DESIGN ADVISORY BOARD Tuesday, May 10, 2022 3:00 PM

TO: Design Advisory Board
FROM: Ryan Morrison, Associate Planner
DATE: May 10, 2022
RE: ZP-21-800; 501 Pine Street

Request: Develop a container kitchen/food truck café on the vacant property.

To: The Design Advisory Board
From: Mary O'Neil, AICP, Principal Planner
RE: 45-47 Lakeside Avenue, ZP22-231
Date: May 10, 2022

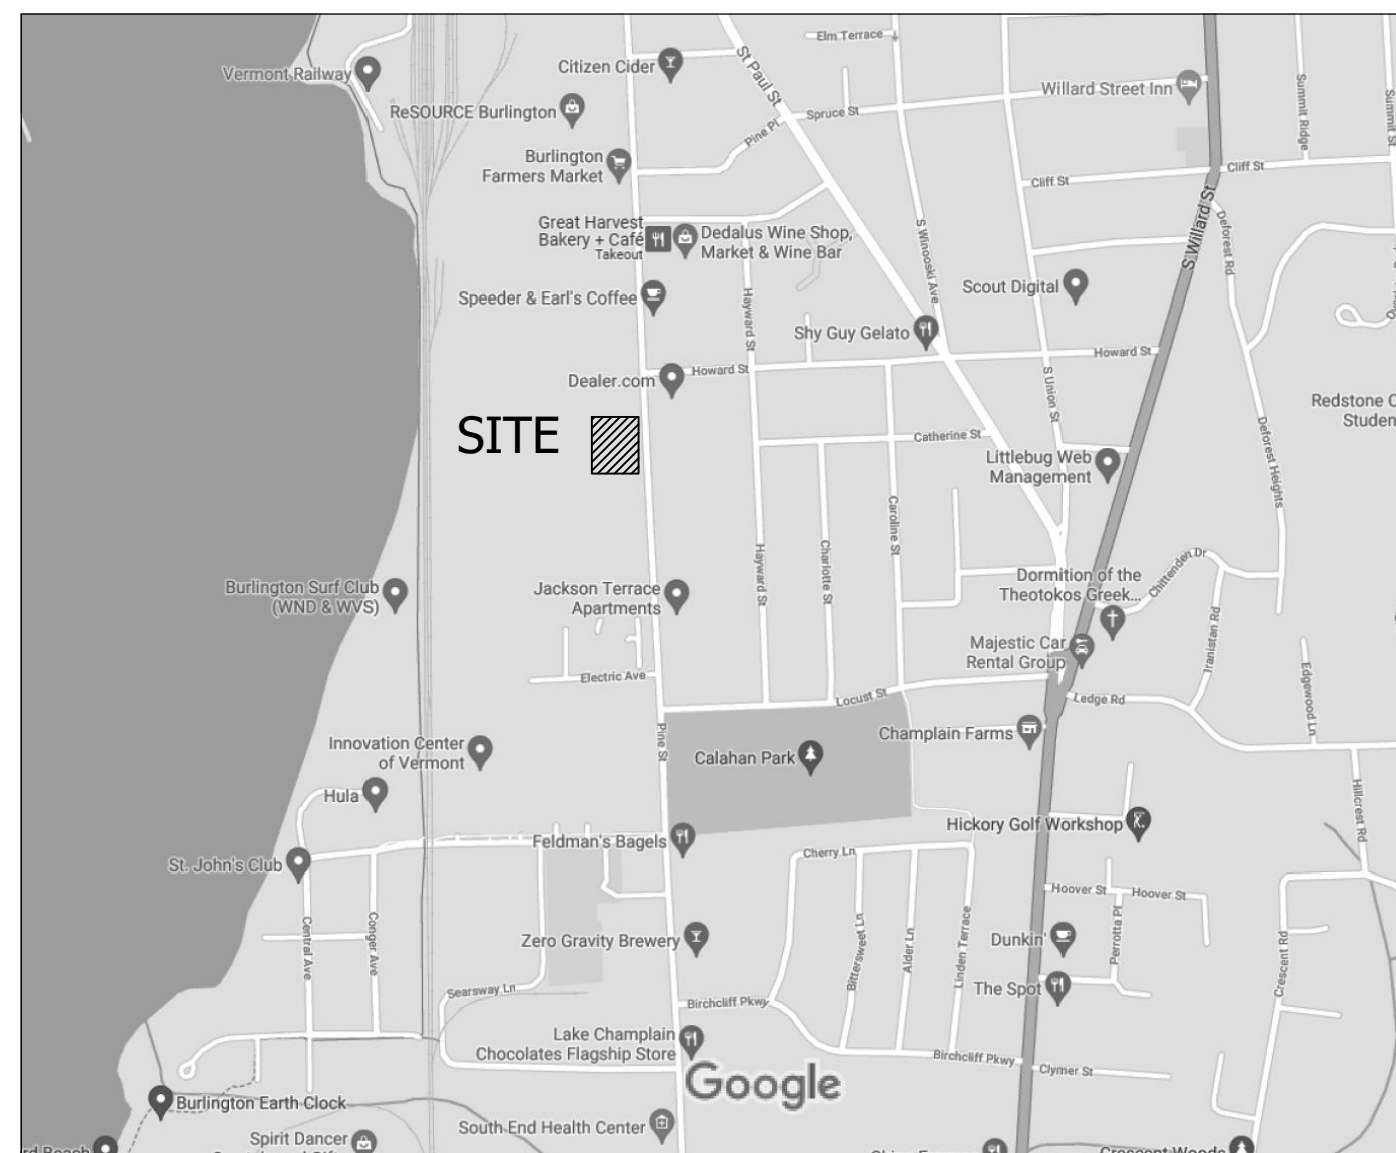
The plans show wall signs for each container café which appear to be compliant with the size and placement requirements/limitations for wall signs. Also included is a rooftop 'the courtyard' sign which is prohibited per Sec. 7.1.4 – Prohibited Signs – *(h) Signs located on the roofs of buildings or structures, or that project above the roof or parapet line.* This signage will need to be removed from the plans.

Underground electric/water utilities (and assuming gas) will be used. No other infrastructure is noted. Venting will need to be screened as much as possible from view from the public street and neighboring properties.

1. Remove the rooftop 'the courtyard' signage from the plans.
2. Provide specific dimensions of each wall sign.
3. Submit documentation/plans for any remedial actions as they pertain to the brownfield site and the Pine Street Canal Superfund Site.
4. The applicant should consider installing one-way traffic signage and pavement markings.
5. Provide additional information on the retaining wall – particularly noting the height.

PROPOSED BUILDING ELEVATIONS

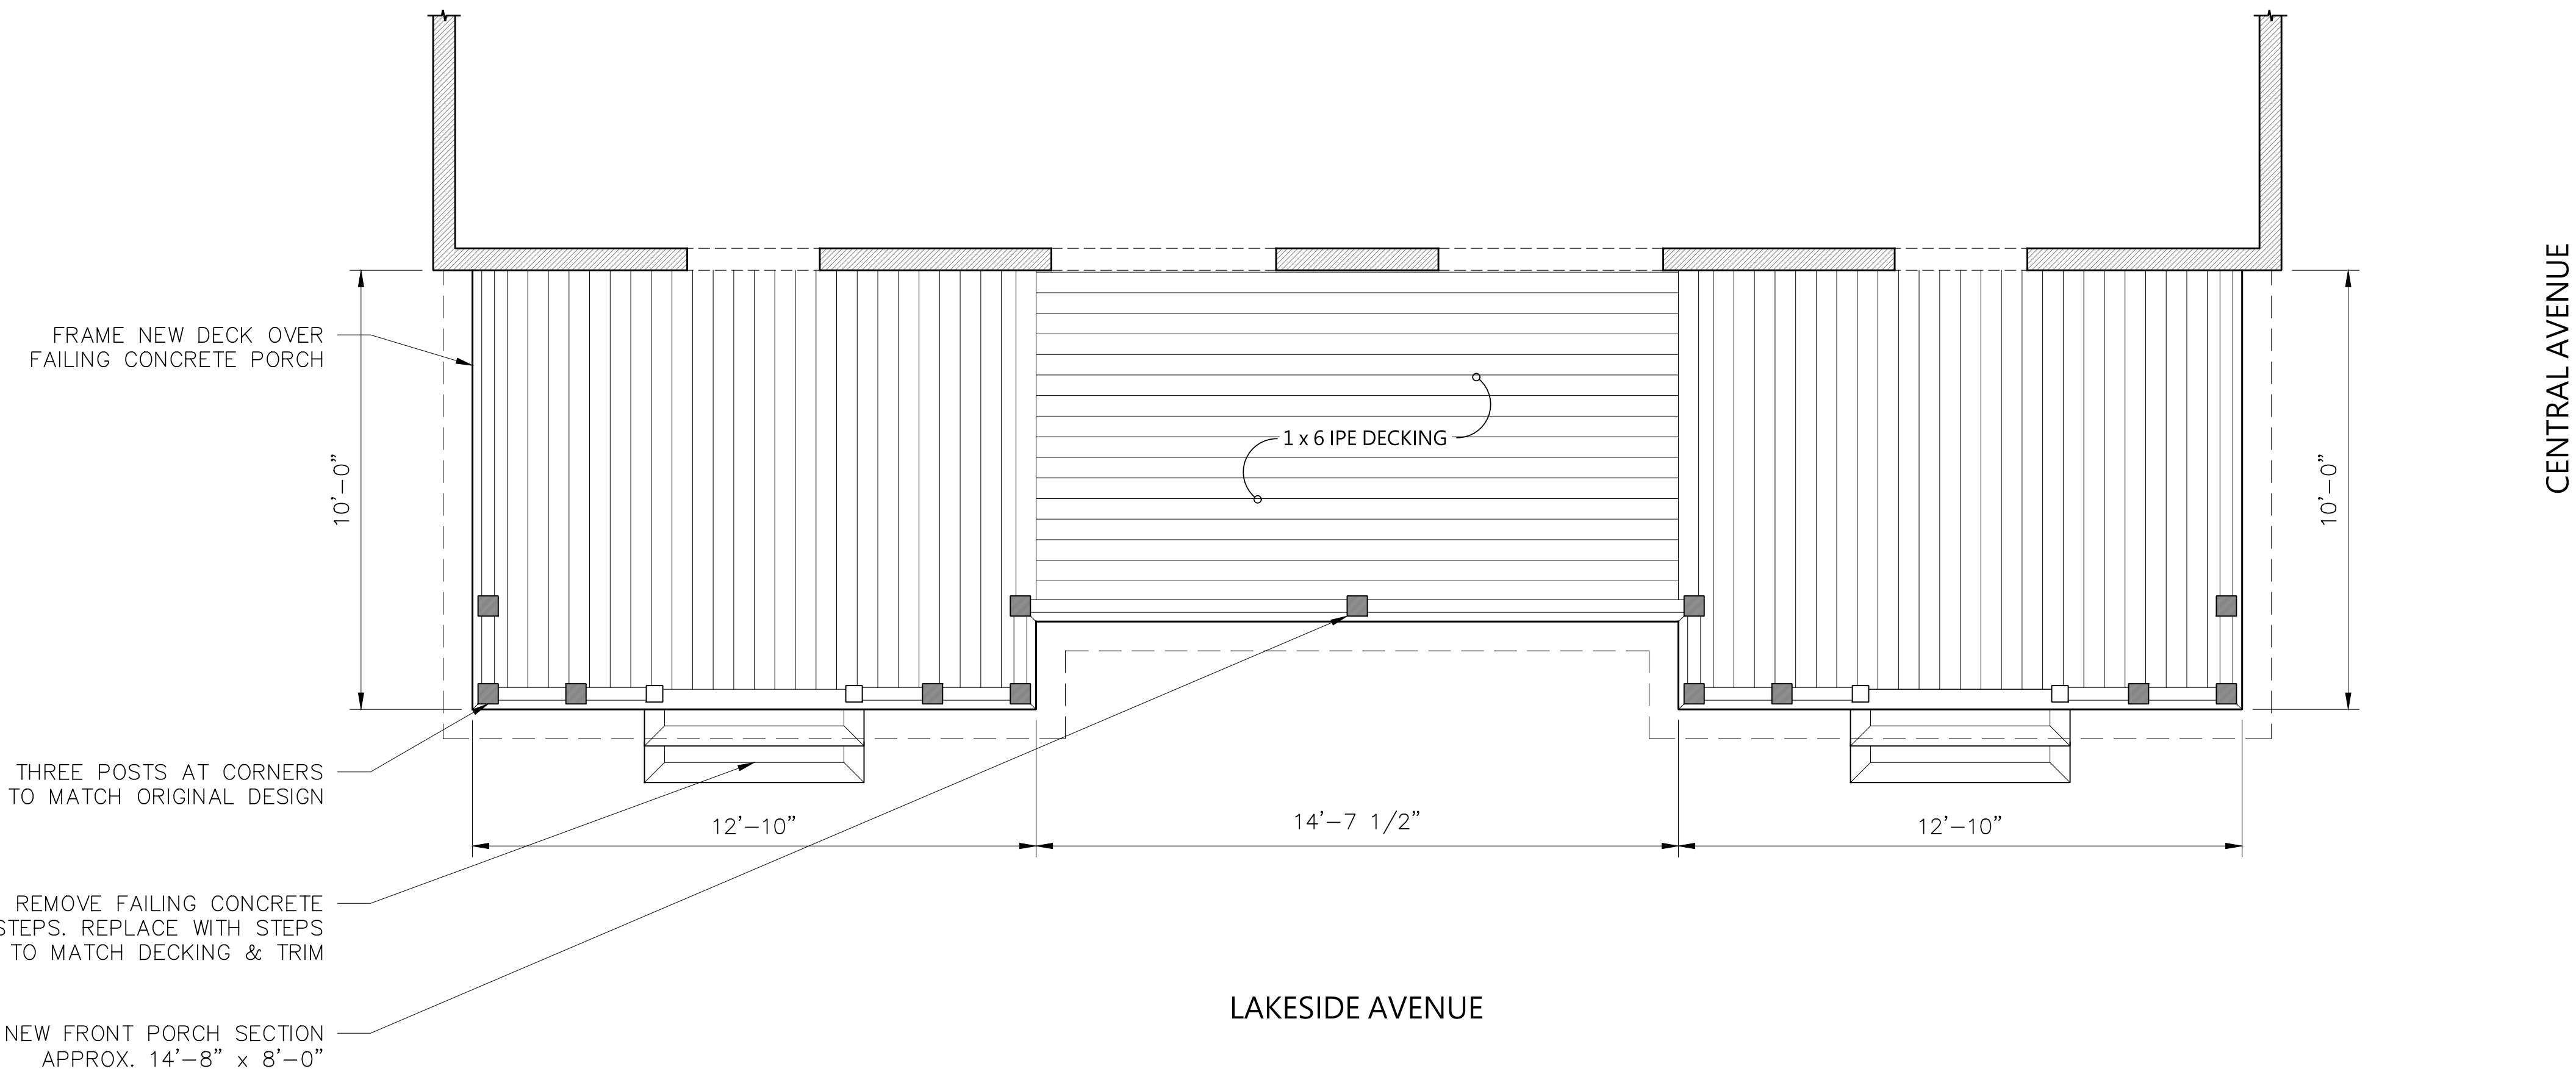
1. First floor primary (north) façade, enlargement and change of fenestration pattern.

In general, the alterations proposed will enhance the streetscape. The porches are a pleasant amenity, but the configuration is not consistent with the earlier appearance of the building, and likely increases lot coverage above what is likely a nonconforming percentage for the zoning district. A site plan, and lot coverage calculation are necessary.

Moldings are proposed to be retained or replicated. The slate roof will remain (although there is an annotation on the project plans that the existing standing seam will be retained on the main

The front porches appear to be enlarged in footprint (depth to house) in this proposal, as well as connected to each other. No site plan has been provided to determine a change in their scale or

- If exterior lighting is proposed, fixture information and light levels need to be provided to staff for review and approval.
- The applicant shall provide information about the following, and illustrate on a site plan/building elevation as appropriate:
 - Existing and proposed lot coverage
 - Mailbox locations
 - Trash/recycling facilities
 - Utility connections
 - Any other mechanical equipment
- The applicant shall provide a site plan to determine if the footprint of the porches are proposed for alteration, and analyze the impacts to lot coverage.
